Millstone Nuclear Power Station, Unit No. 3
 Reporting of Potential Significant Deficiencies
 in Design and Construction: Solid State Protection
System - Undetectable Failure (SD-26)

Solid State Protection System - Undetectable Failure

SOLID STATE PROTECTION SYSTEM MASTER RELAY AND OUTPUT RELAY TEST

SIMPLIFIED SKETCH OF TYPICAL SAFEGUARDS ACTUATION RELAY TESTING IN THE SSPS

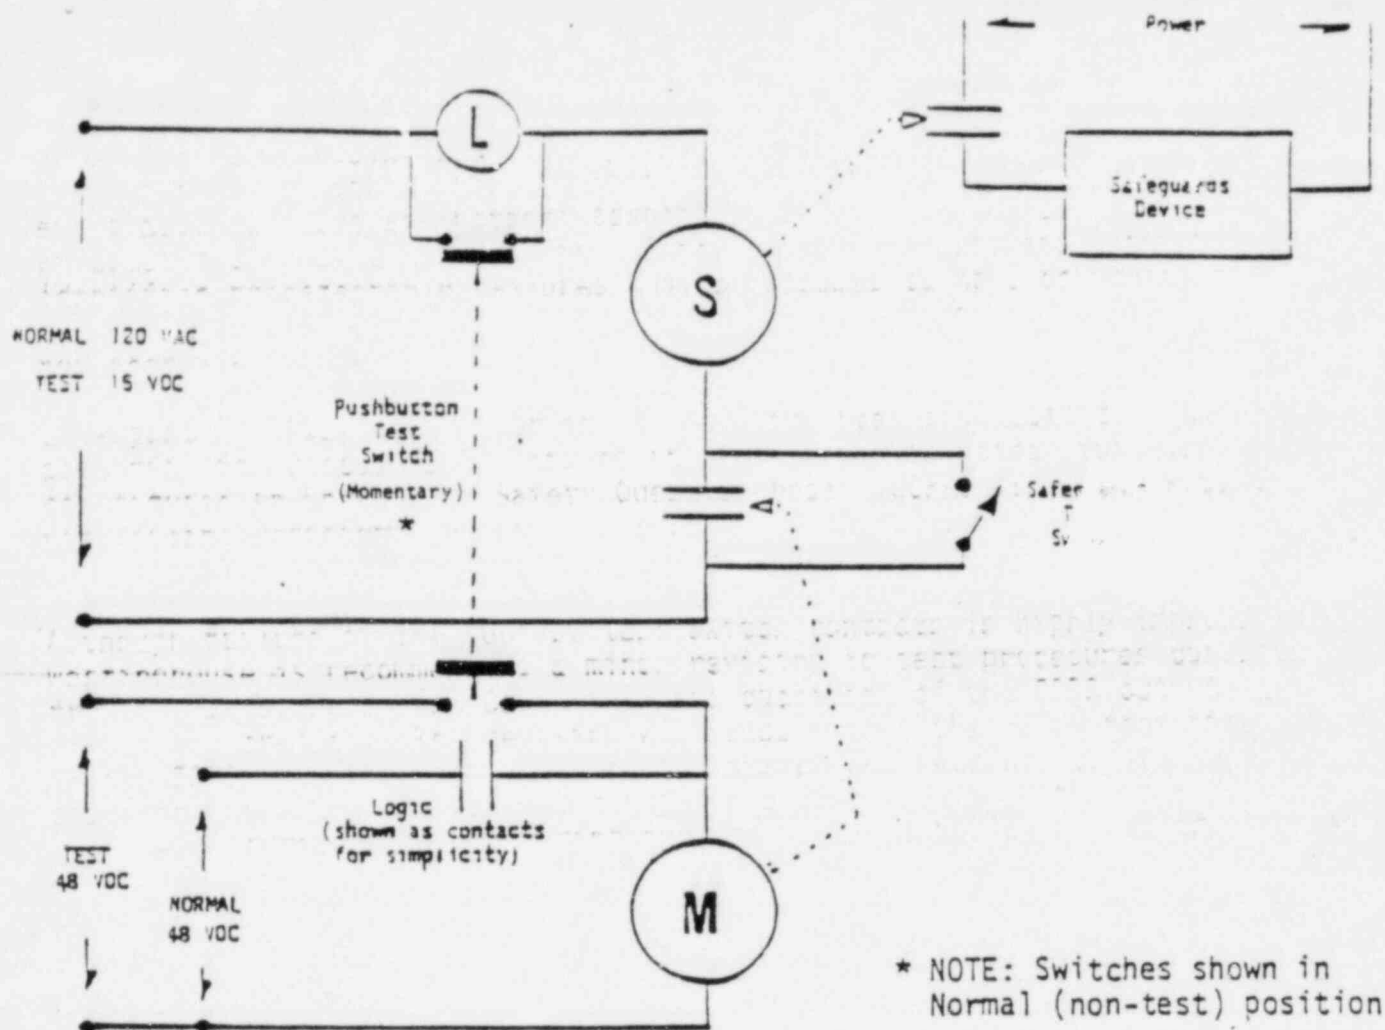
As mentioned above, output relay coil continuity is confirmed at the SSPS, without operating the relay, by reducing the circuit voltage to 15VDC from 120VAC. As shown in the sketch, operation of the master relay by means of the pushbutton test switch also removes the shunt from the SSPS proving lamp and allows the 15VDC to energize it to confirm the continuity of the output relay coil.

Upon completion of the master relay and output relay coil continuity tests, 120VAC circuit voltage is restored. However, if the switch contacts which shunt the proving lamp should fail to reclose as expected, 120VAC would be applied to the lamp in event the system were called upon to operate. Depending on the output relay coil impedance and the number

of output relays being operated by the master relay contacts, the current through the lamp could cause it to burn open before the output relay(s) energized. In such an instance associated Safeguards devices in the affected train would not actuate. Since, during circuit analysis, all identified nondetectable failures must be assumed to have occurred, the redundant Safeguards actuation train must be assumed to be similarly, if not identically, failed.

PROBLEM: If contacts shunting proving lamp L do not reclose when pushbutton is released and system is return to Normal, then 120 VAC would be applied to Slave relay coil thru the proving lamp if Safeguards actuation were called for by the Logic "contacts".

Although failure of the subject test switch contacts is highly improbable, Westinghouse is recommending a minor revision to test procedures conducted from the Safeguards Test Cabinets where operation of the SSPS output relays is verified. The revision will ensure that the relay test circuits in the SSPS operated properly when the system was returned to its normal operating mode. The procedure changes are described in Attachment III and are recommended until Westinghouse completes a review of its consideration of design changes.

Perform the test described below immediately following completion of the Solid State Protection System (SSPS) Output Relay Testing.

This test will ensure that the pushbutton or relay contacts used to shunt the output relay continuity lamps located on the Output Relay Test Panel have returned to the closed position.
